**SUBMISSIONS OF THE APPELLANT, STONE CREEK RESORTS INC.**

**Appeal of Amended DP for Nordic Spa (PL20240362)  
1 Silvertip Trail, Canmore**

### Area of Development Amendments - Original

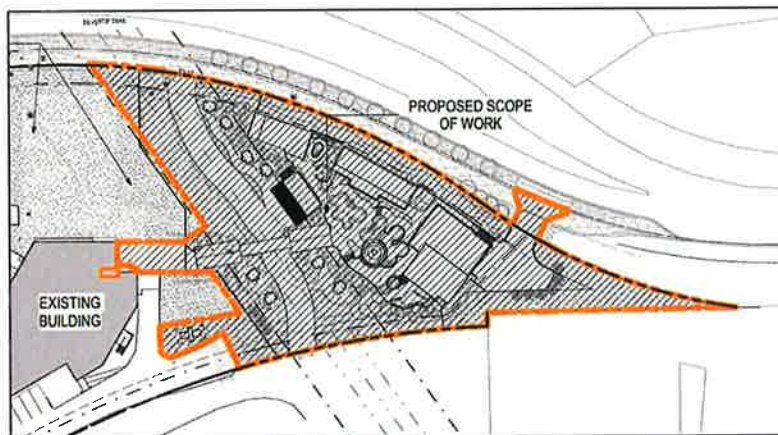
**Amendments Numerous and Misdescribed**

### Original Trees on Site

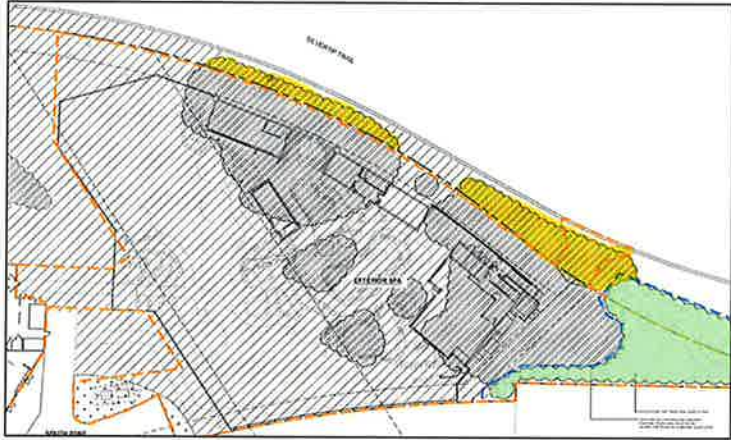
### Screening Trees - Directions of Council

**14.11.6.4** Every application must submit, to the satisfaction of the approving authority, a visual impact assessment which includes:

### Conceptual Design - Pathway, Screening Trees, Retain Lanes

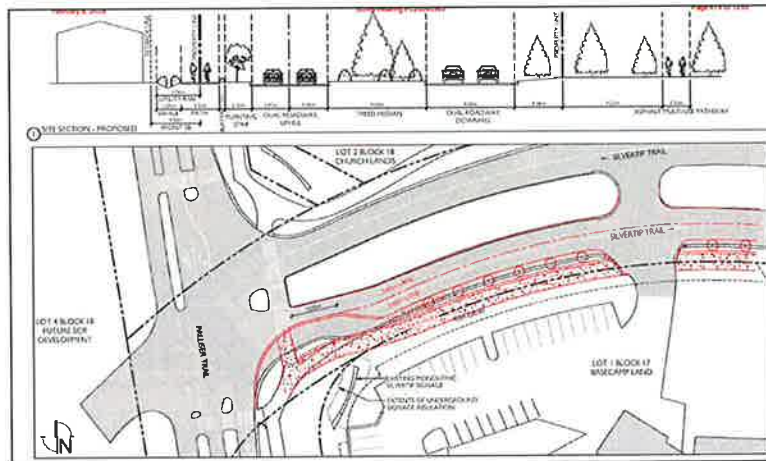
### Conceptual Design - Pathway, Screening Trees, Retain Lanes
